Value Engineering Study

**US 27 RECONSTRUCTION
FROM US 150 BYPASS IN STANFORD TO KY 34
LINCOLN AND GARRARD COUNTIES, KENTUCKY**

**ITEM NUMBER 7-196.00
VE STUDY NUMBER 201204**

Final Report

SKETCH OF RECOMMENDED DESIGN

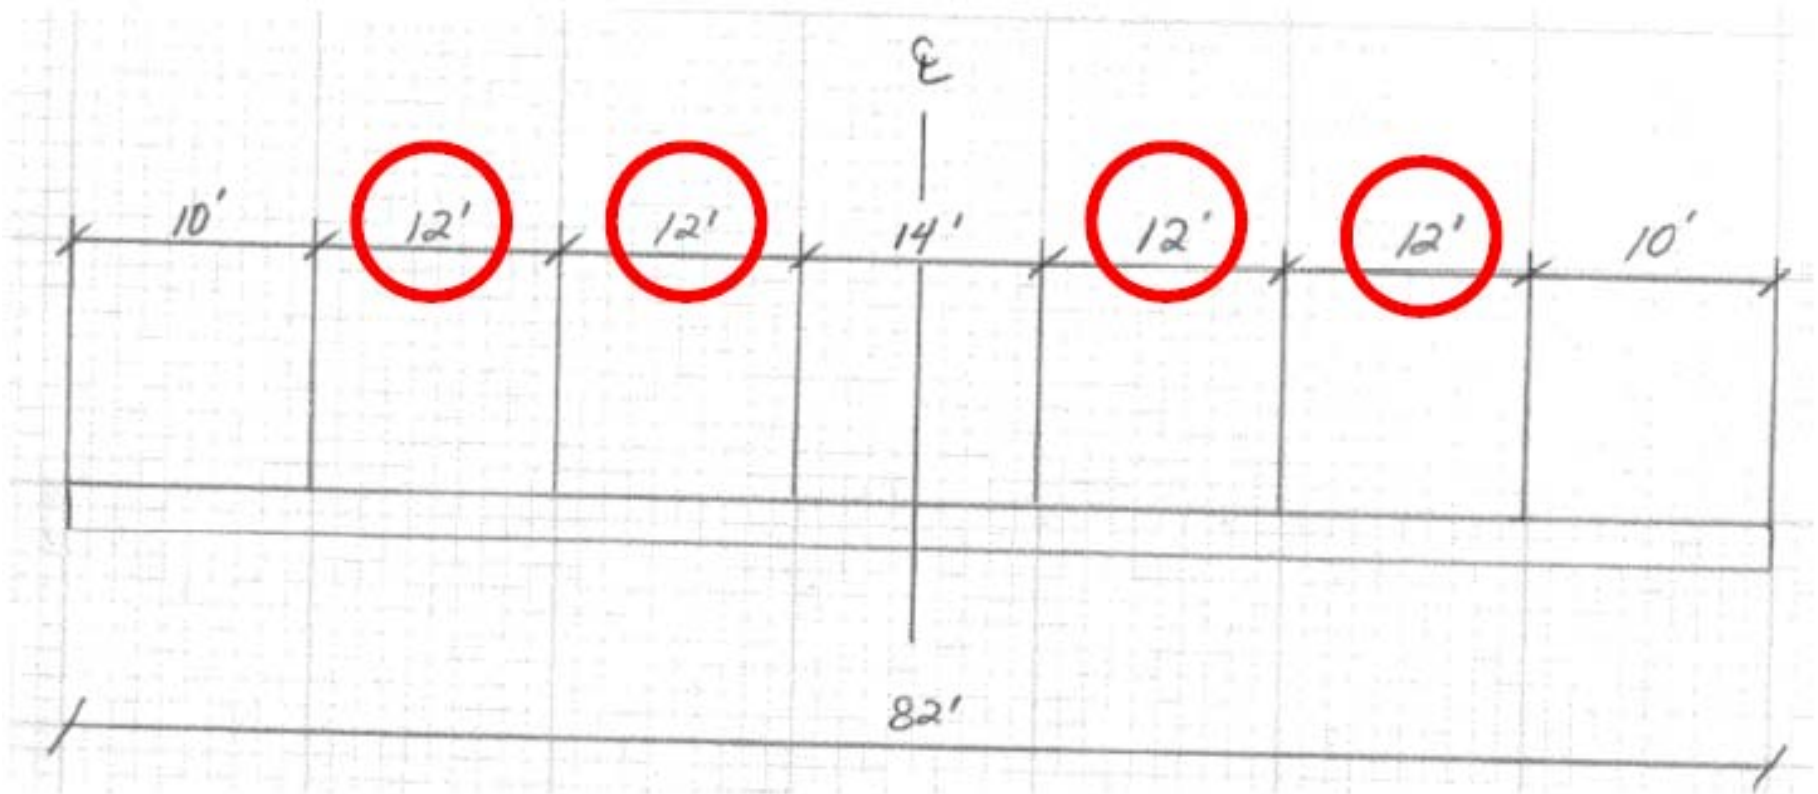
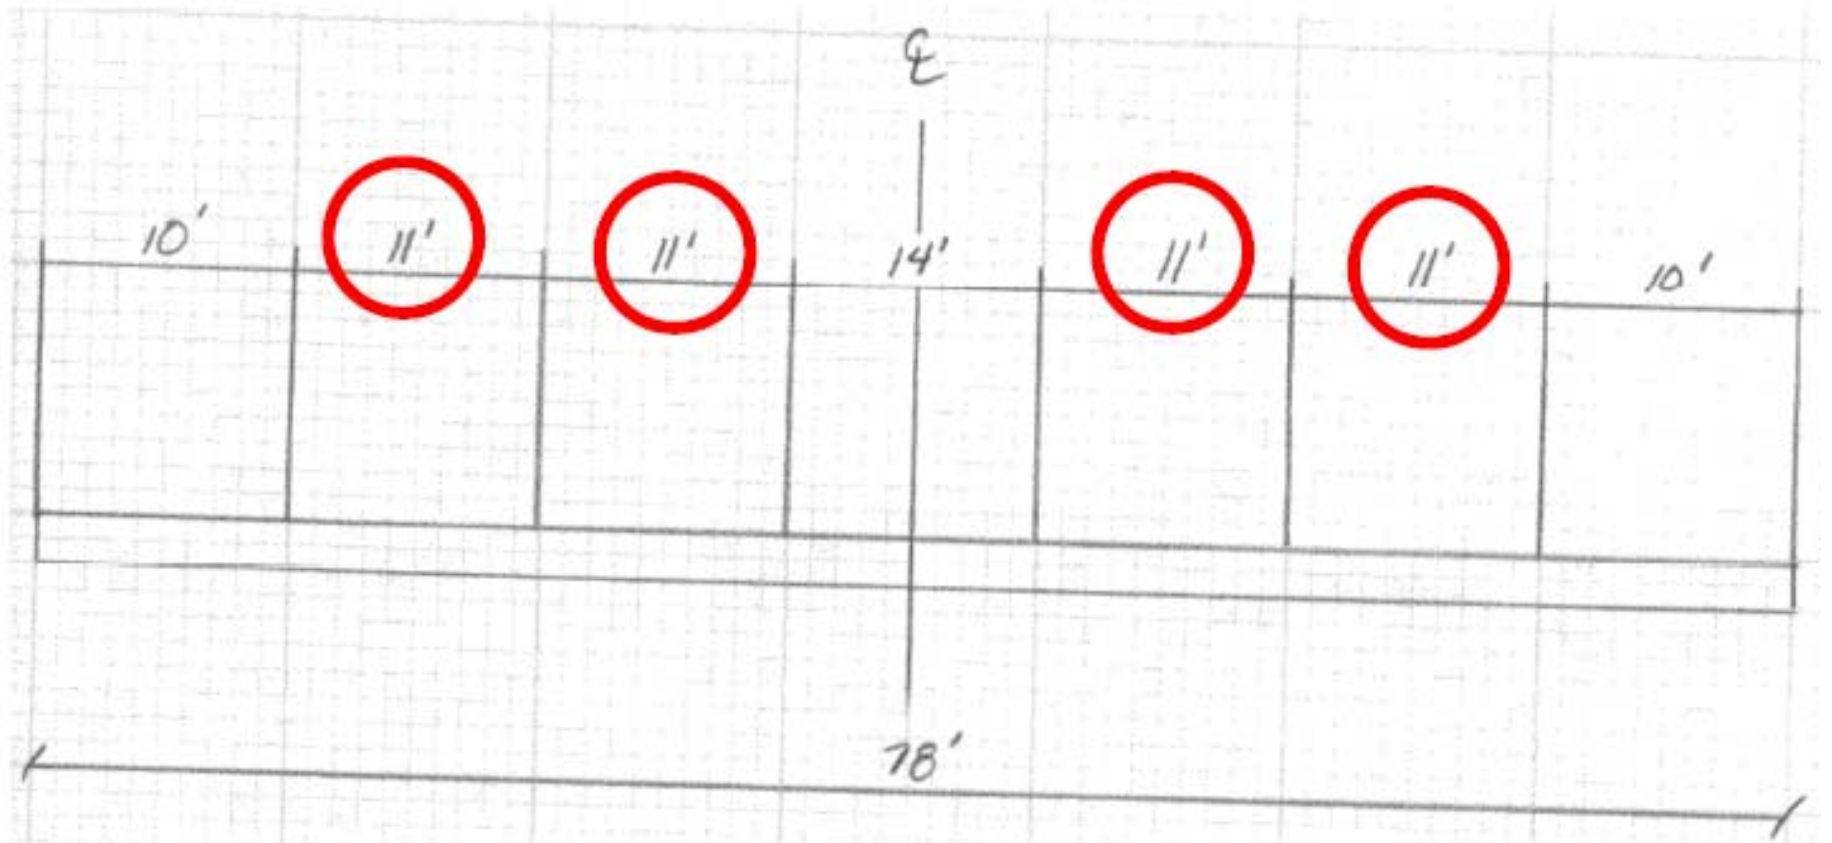
This reduction of the typical section will help minimize the overall cost of the ROW and pavement. ROW and pavement are major costs on this project, and any steps taken to reduce ROW impact and constructed pavement should be considered. This change will not substantially impact the safety or operations of the roadway.

SKETCH OF RECOMMENDED DESIGN

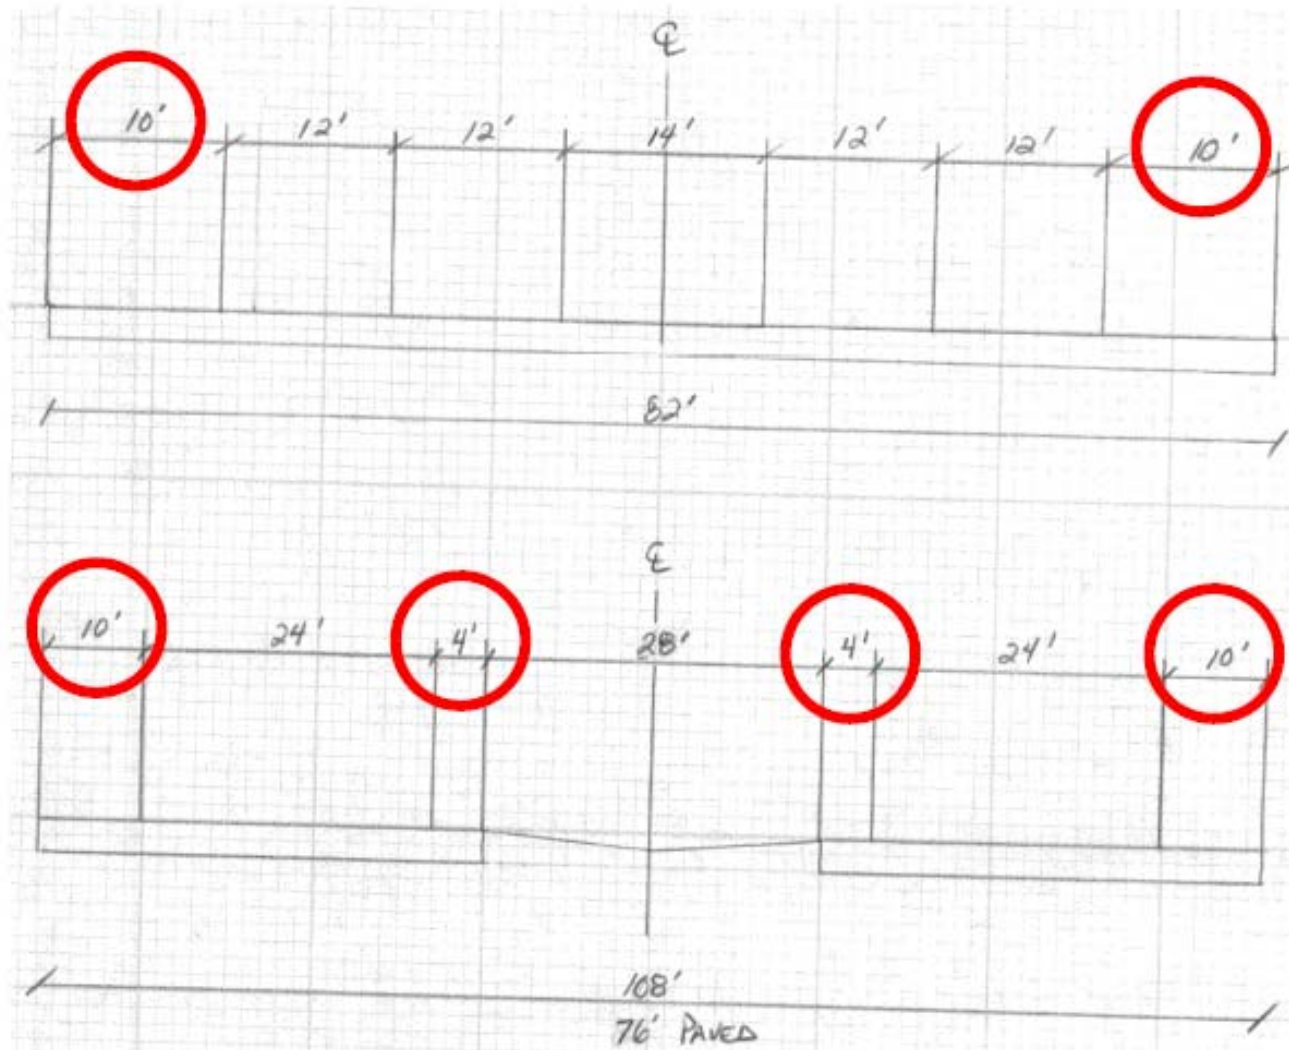
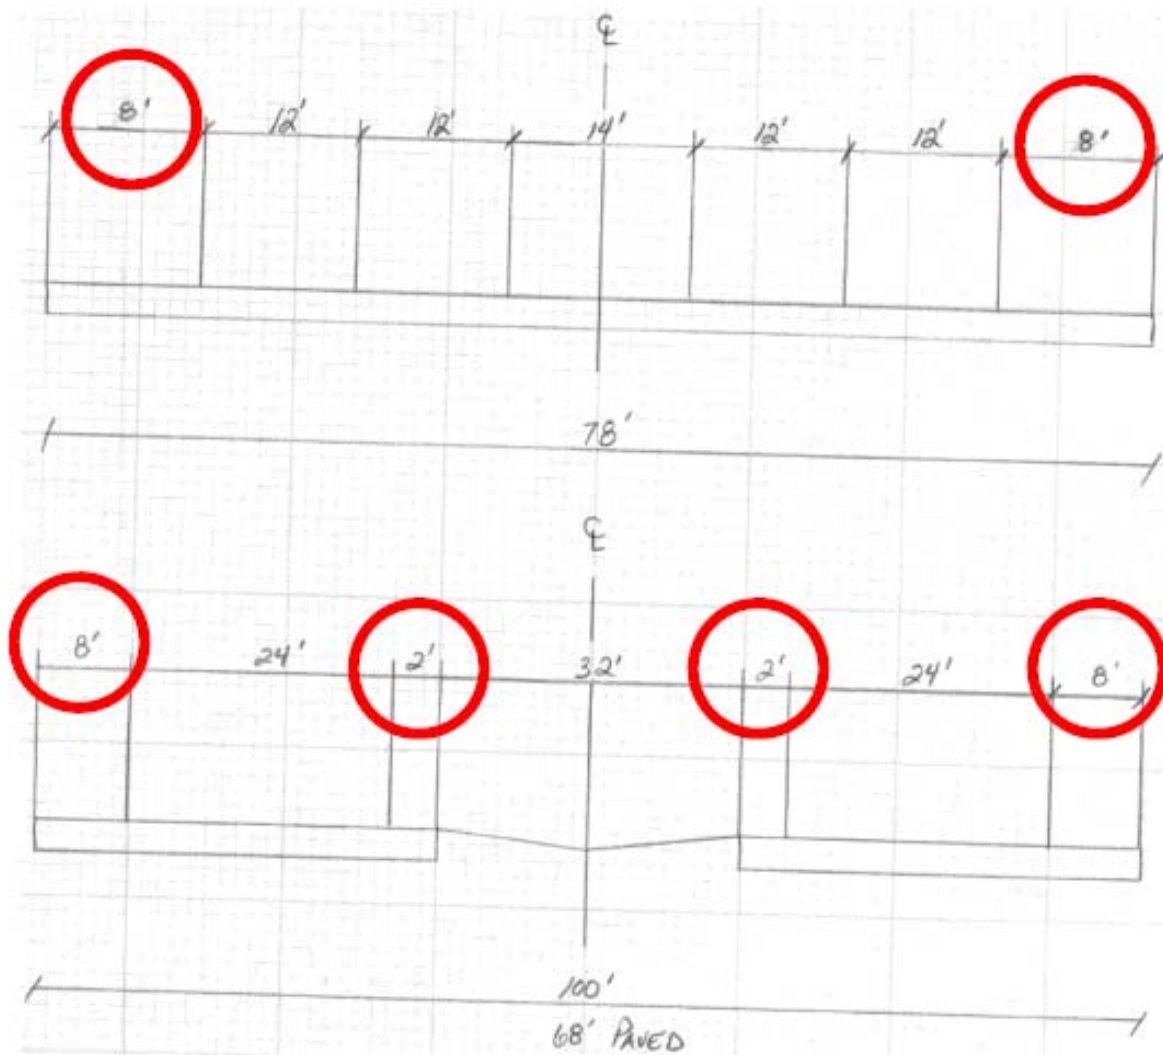
This 2-foot shoulder reduction of the typical section will help minimize the overall cost of the ROW and pavement. ROW and pavement are major costs on this project, and any steps taken to reduce ROW impact and constructed pavement should be considered. This change will not substantially impact the function of the shoulders or median.

SKETCH OF RECOMMENDED DESIGN

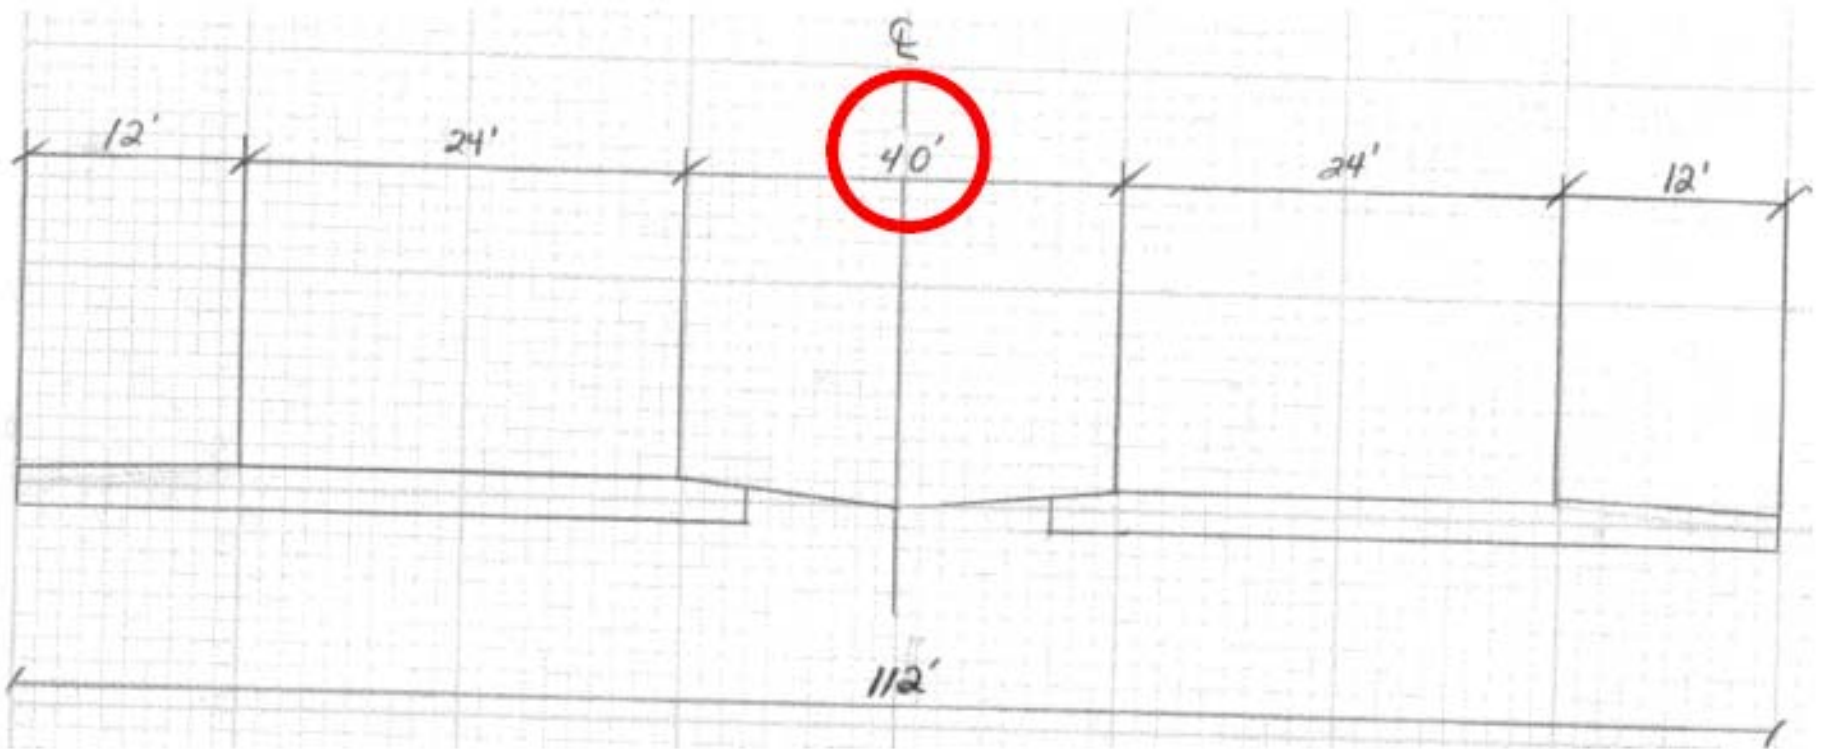
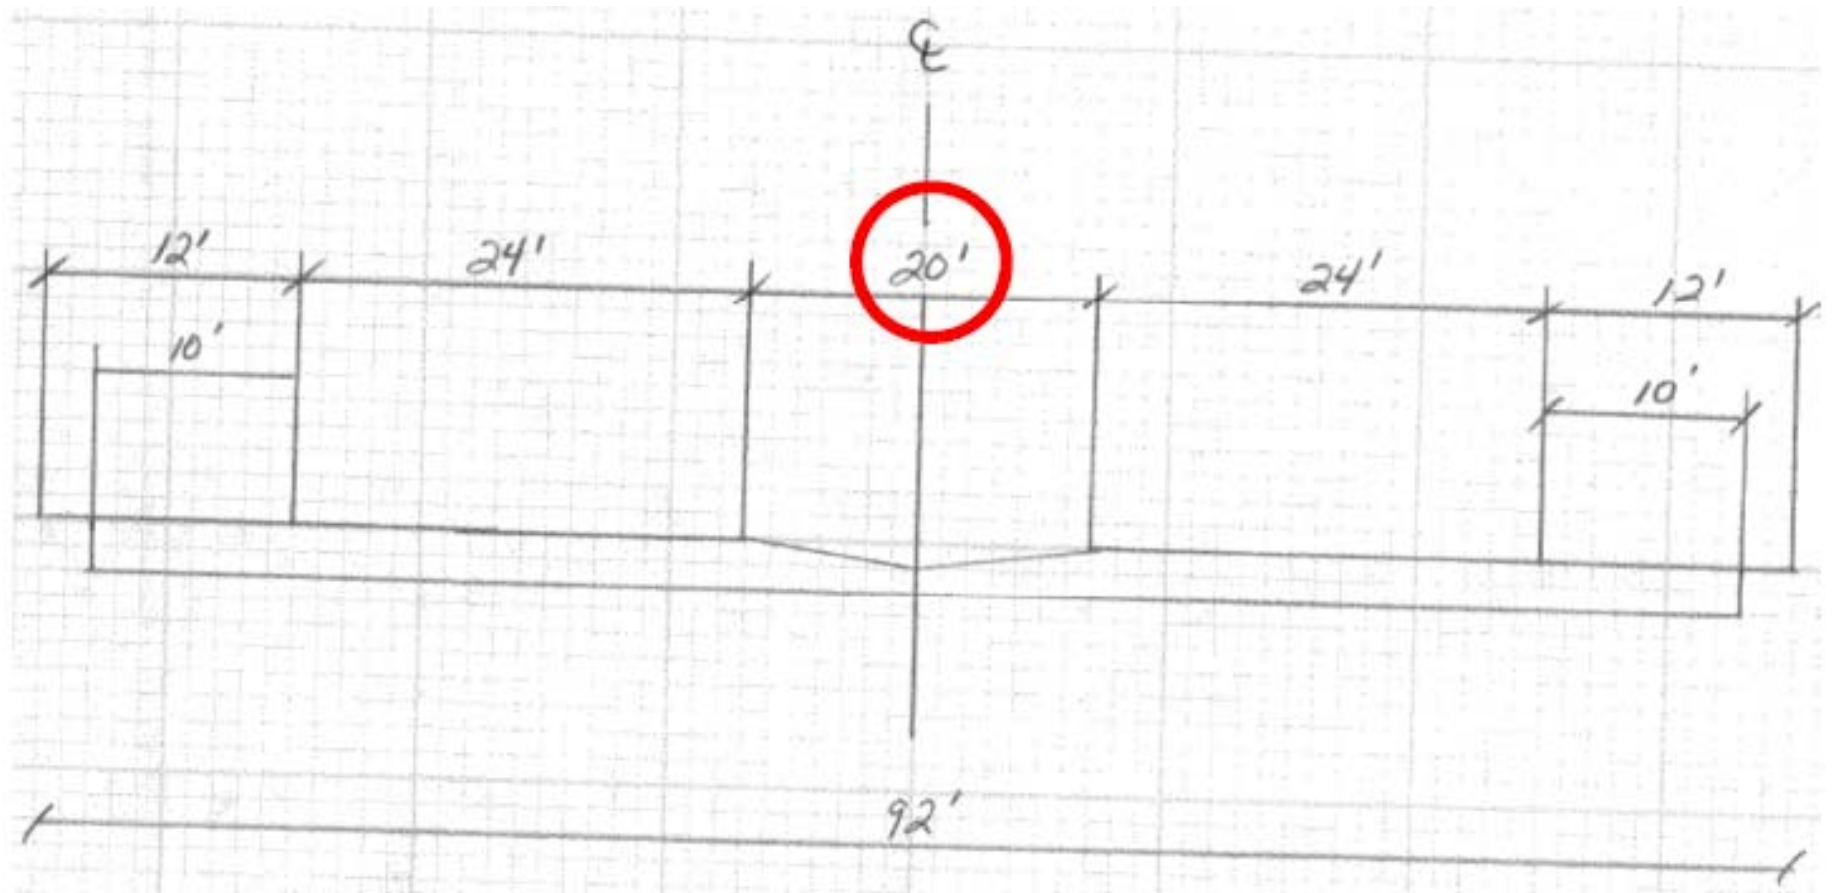
The VE Team recommends using a 4-lane typical section with a 20-foot depressed median to replace the 40-foot depressed median. This typical section shall begin at approximately Sta. 1250+00 and continue throughout the remainder of the corridor.

This reduction of the typical section will help minimize the overall cost of the ROW. ROW is a major cost on this project, and any steps taken to reduce ROW impact should be studied. Although this reduces the clear zone width within the median, this design still allows for offset left turn lanes or standard left turn lanes that allow U-turns for passenger vehicles. This recommendation may be modified to a median width of 25 or 30 feet to allow for a larger clear zone.

Example of Current Roadway Configuration and the Recommended Roadway Diet Configuration

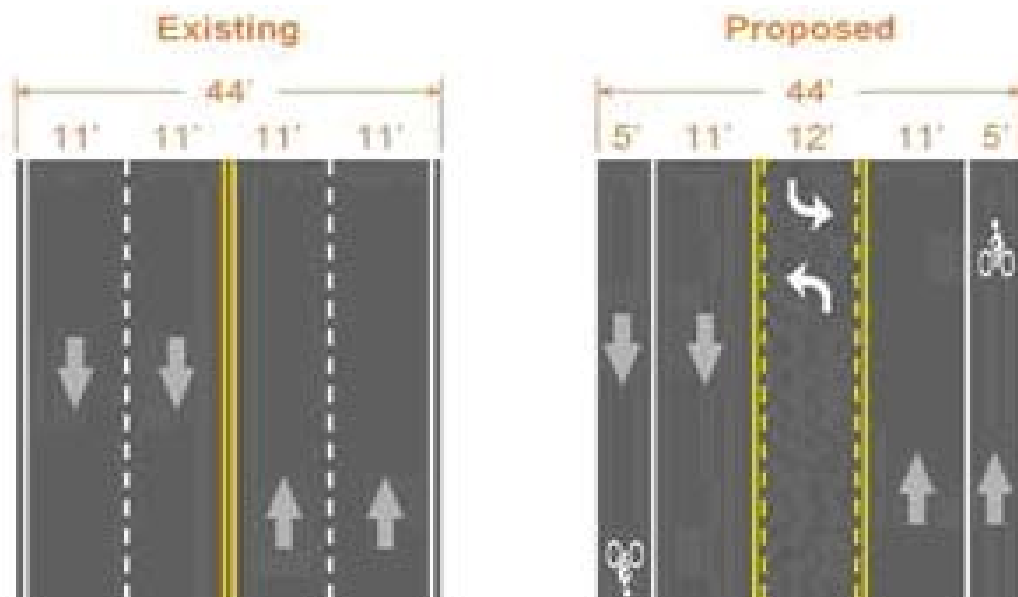
Utilize a road diet in downtown Lancaster. The bypass will remove some traffic from downtown, freeing up capacity. The existing 4 lanes will not be needed. One northbound through lane, one southbound through lane, and one two-way left-turn lane can be striped, allowing for bike lanes in both directions on US 27 through town. The downtown section of US 27 south of KY 52 is a designated bike route, part of the Midland bike route. If the multi-use path is built to Logan Hubble Park, these bike lanes could possibly be extended to connect to the multi-use path in the future.

SKETCH OF RECOMMENDED DESIGN

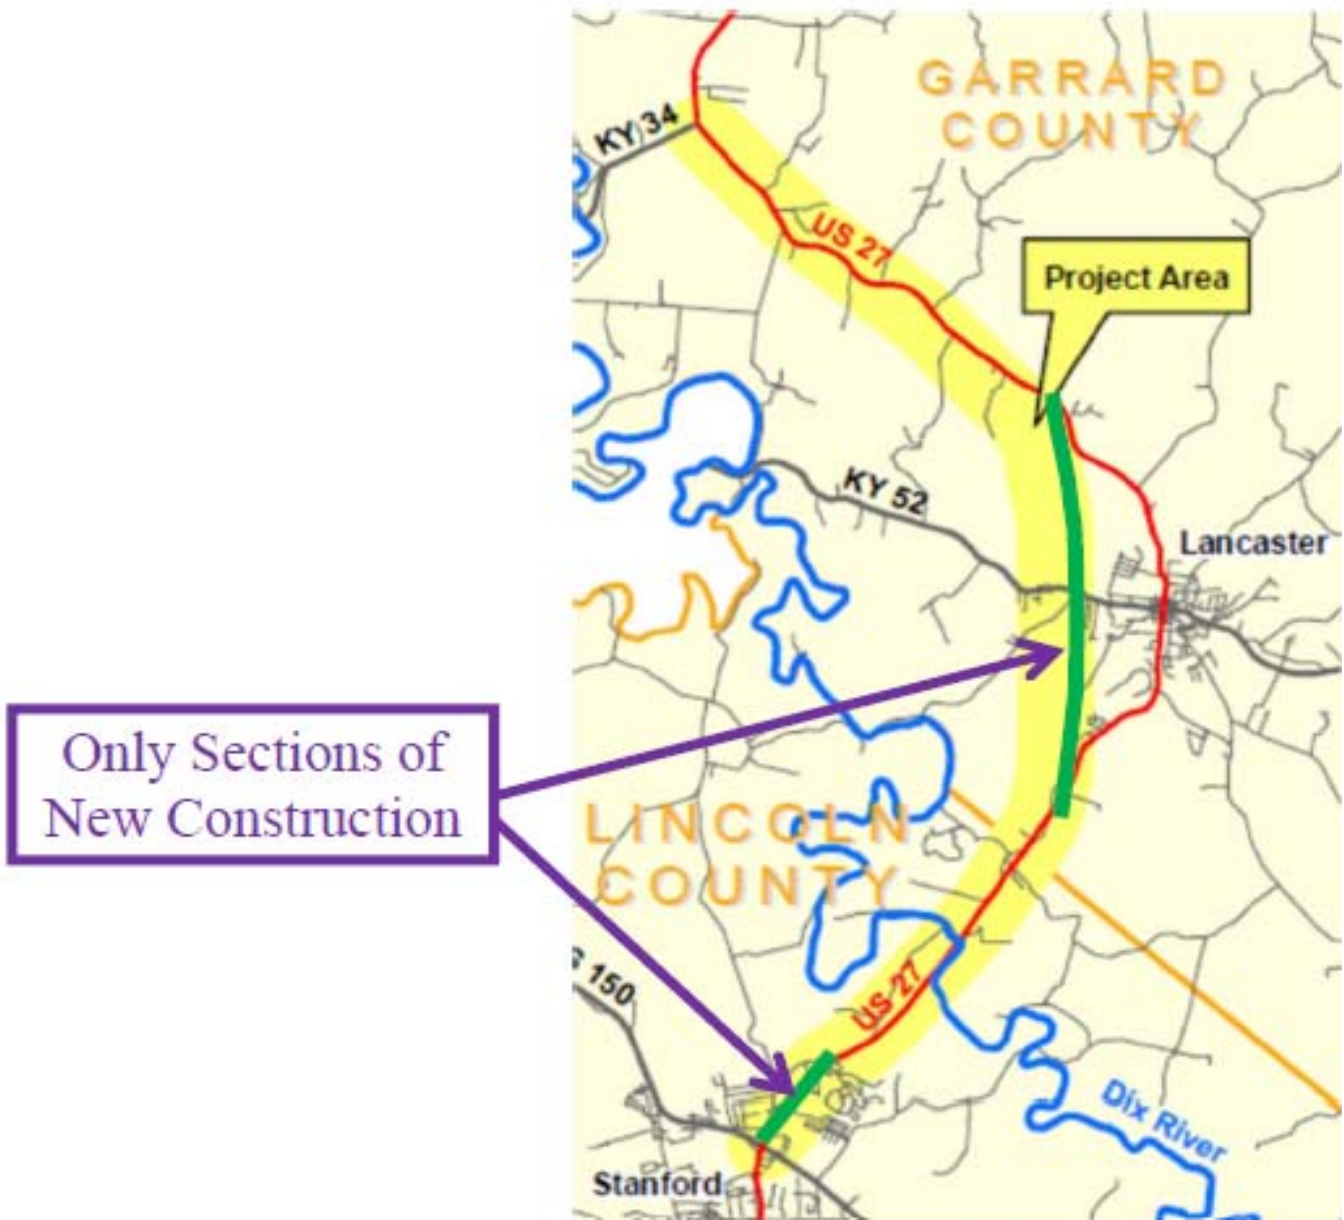
The traffic study indicates that, in the design year, the projected corridor ADT is likely to be less than 12,000 vehicles on the unimproved sections which would accommodate an acceptable level of service. The southern section and the area through Lancaster show the most need in terms of congestion and therefore would benefit the most from a reprioritization of construction sections.
